July 26, 2012

**RE: Storm Water Inspection at College Avenue Reconstruction – Franklin  
County Permit # 4GC03831\*AG**

Figure 1 Inlet protection required

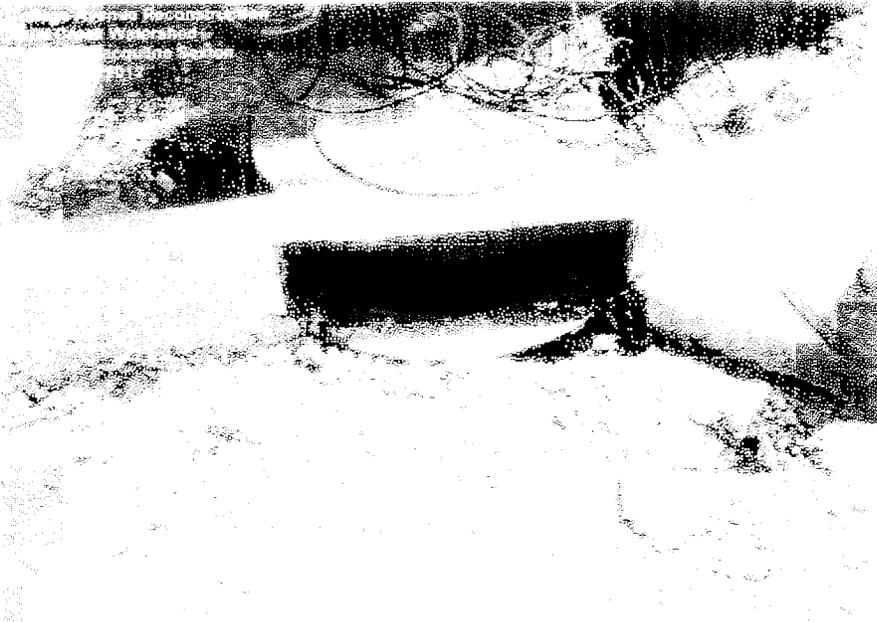
- Inlet protection must be established on the south end of the site or demonstrate an appropriate alternative. (See Figure 1 & 2)
